**ON-SITE SEWAGE DISPOSAL SYSTEM
 HOWARD COUNTY HEALTH DEPARTMENT
 BUREAU OF ENVIRONMENTAL HEALTH**

SUBDIVISION: Pindell Crossing LOT NUMBER: A (60)

ADDRESS: 7500 Pindell School Road PROPERTY OWNER: NVR Inc.

LDE Inc. Engineers, Surveyors, Planners 9250 Ramsey Road, Suite 106 Columbia, Maryland - 21045 (410)715-1070 - (301)596-3424 - FAX(410)715-9340		SCALE 1" = 30'
DESIGNED BDB	PLOT PLAN PINDELL CROSSING PARCEL 60	
DRAWN JLM		
CHECKED BDB	TAX MAP 41 GRID 13 & 14 PARCEL 201 5TH ELECTION DISTRICT HOWARD COUNTY, MARYLAND	
DATE 8/2001	BUILDER NV HOMES 2200 DEFENSE HIGHWAY SUITE 301 CROFTON, MD 21114 (301) 858-0522 (410) 721-4703	JOB NO. 01-031
		FILE NO.

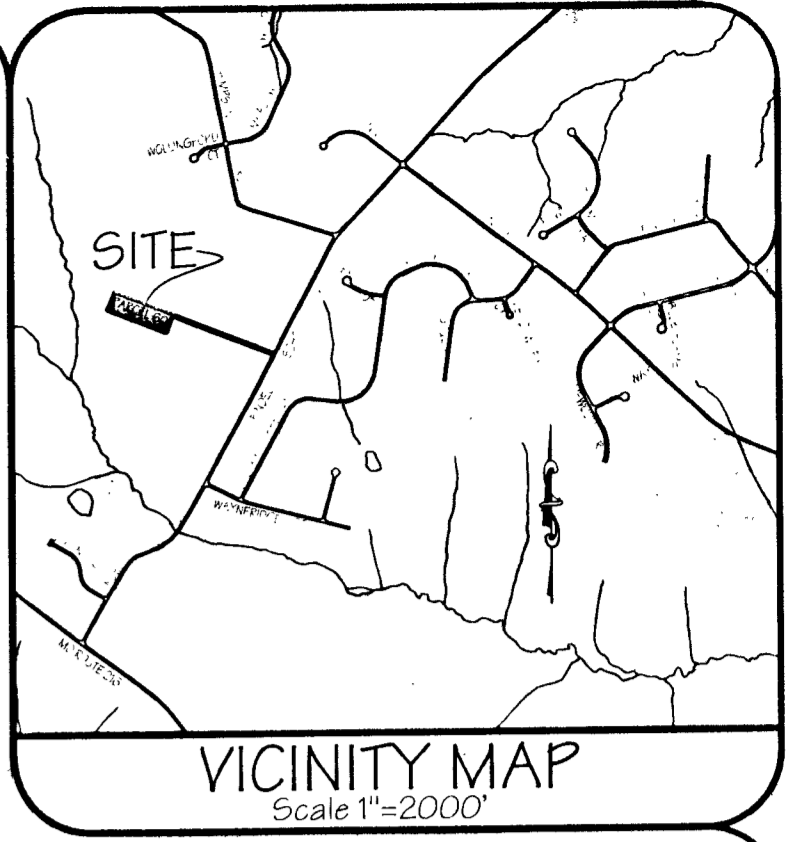
PRE-CONSTRUCTION 10/3/02 Lot staked, contours maybe off. Inset 1/14 trenches 70'/80'/90'/100' 10' CTC House corner changed (SO)

INSTALLATION 10/6/02 Tanks set, 1 1/2 trenches installed (SO)

10/9/02 OK to cover all work, Pump & Alarm tests needed (SO)

10/24/02 Pump & Alarm tests OK (SO)

1,000 Gallon U16 PROANE TANK

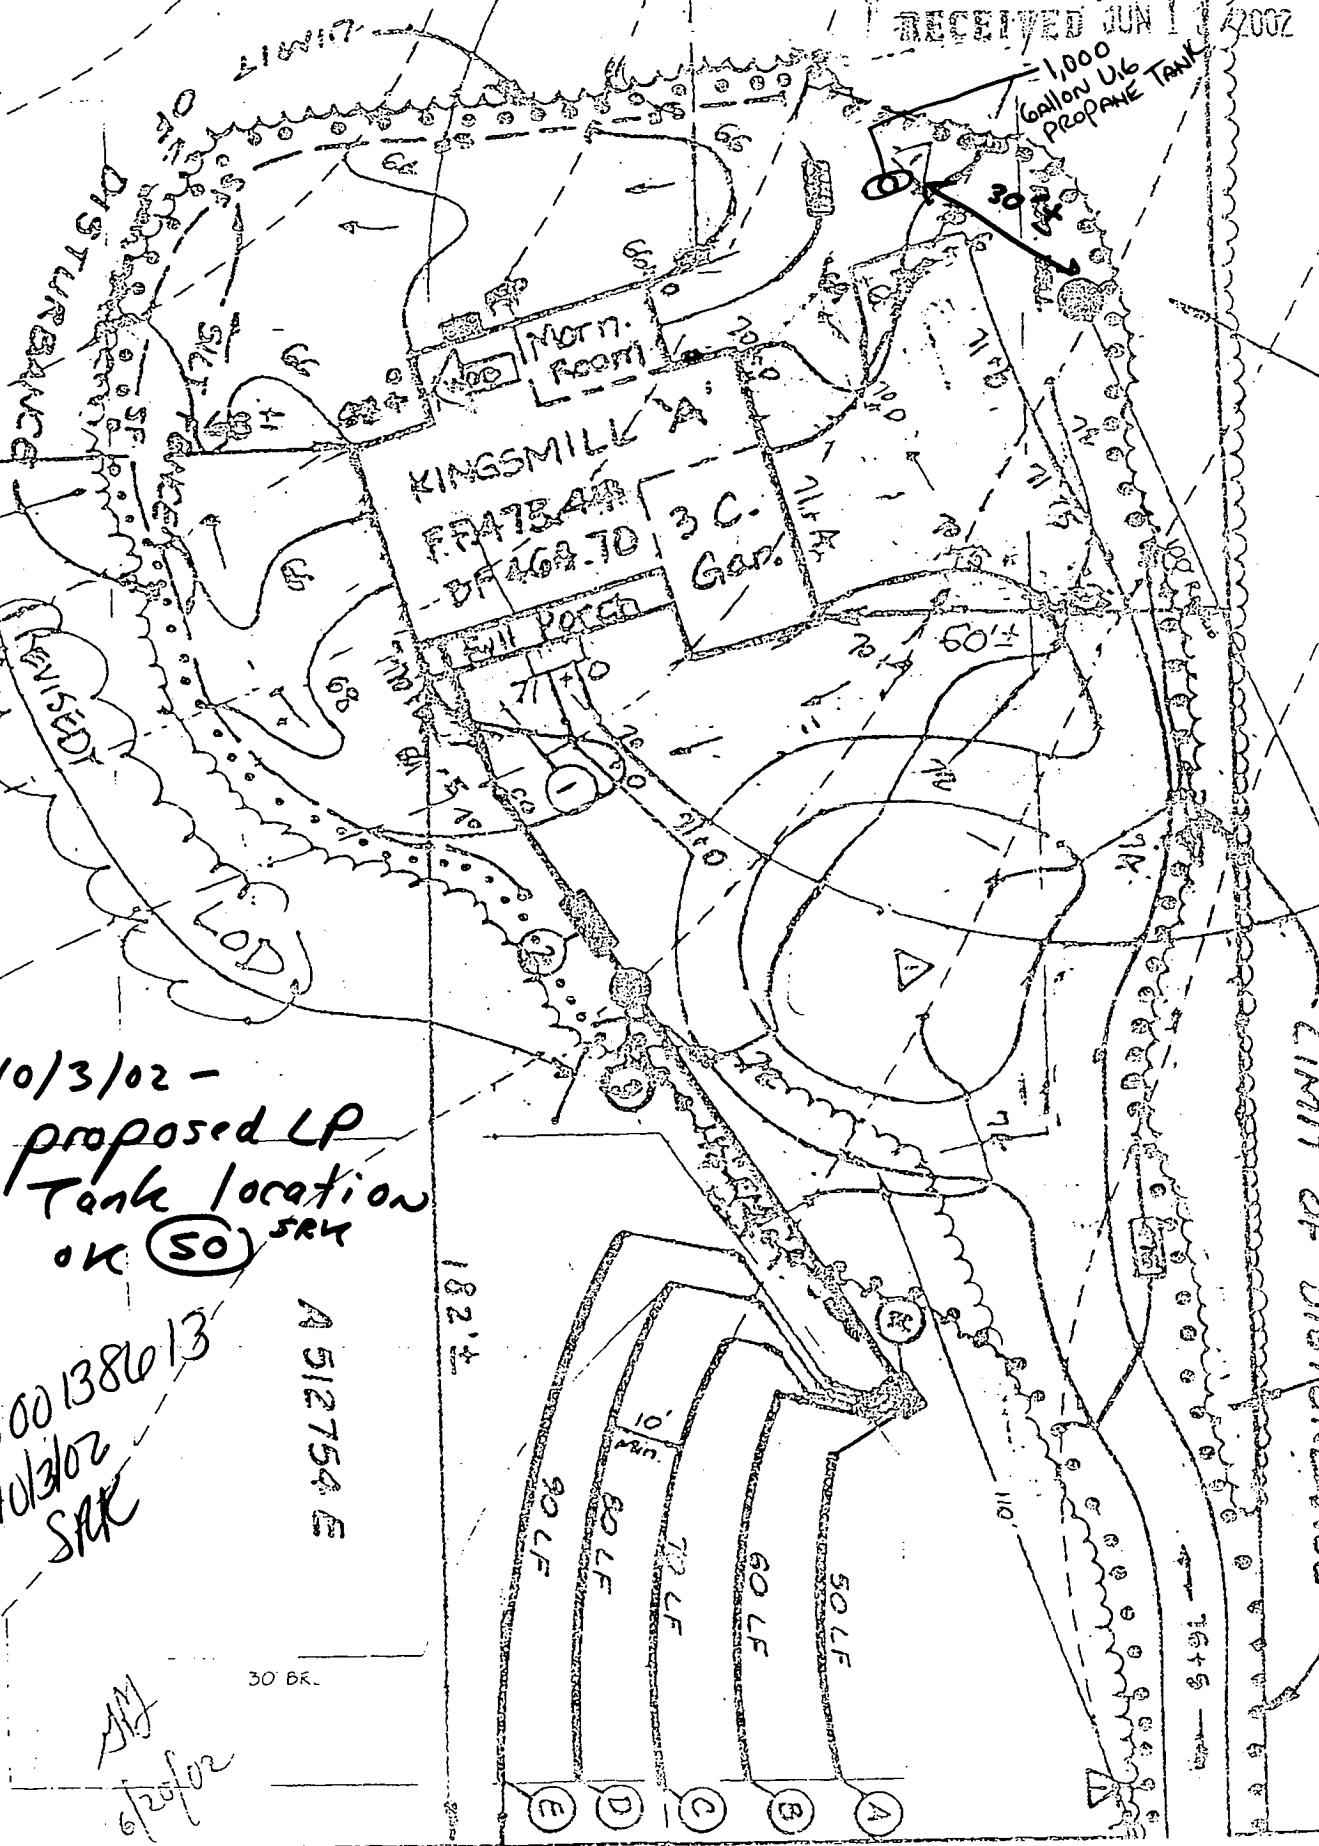
10/3/02 -
proposed LP
Tank location
OK (50) SRK

FLOORPLAN

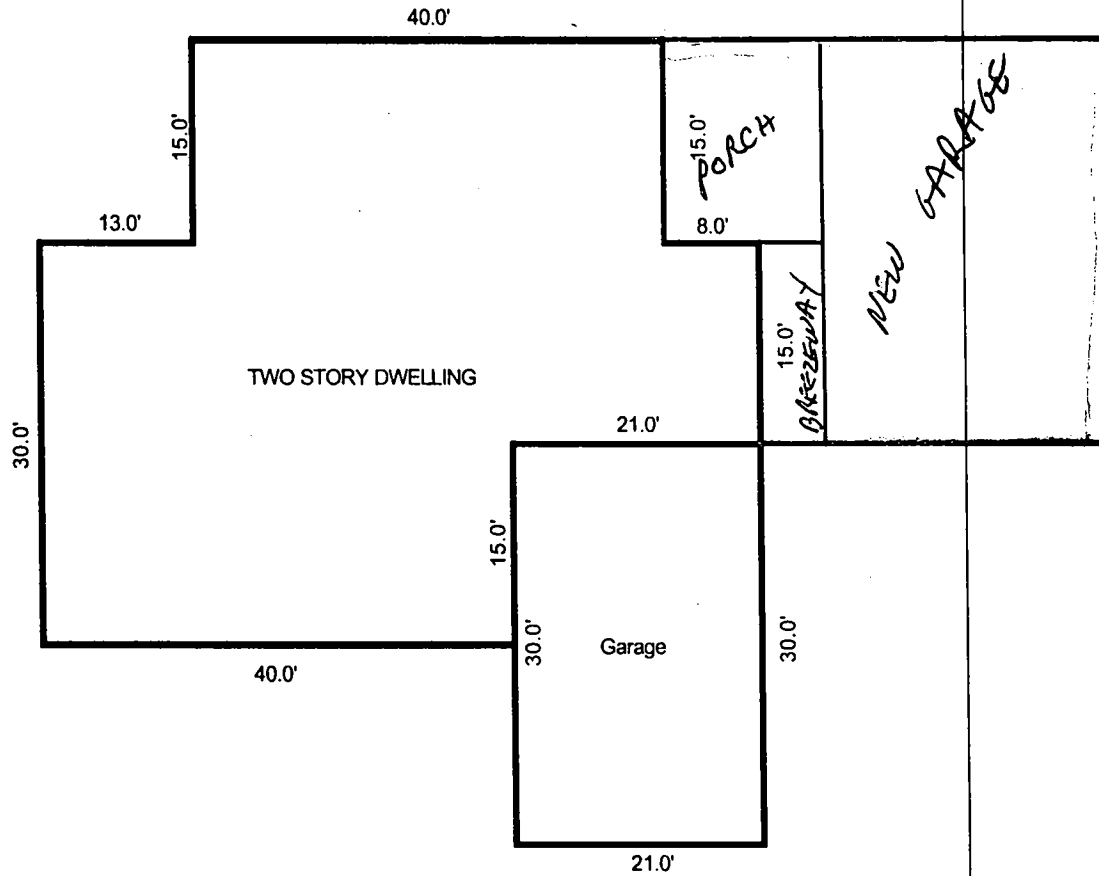
I would like to apply for a variance on a request to build a garage adjacent to my existing garage that would be within a distance of 15 feet from my well. I have a very narrow lot and not much space to build a 2 car garage. The garage would be for the express purpose of housing additional vehicles. For the proposed plan to work I must get within 15 feet of the well. See the attached site plan.

= PROPOSED

10/21/03 - Local HD recommends
approval of the variance. -SRK

OK SRK
11/4/03
See Attached
Variance letter
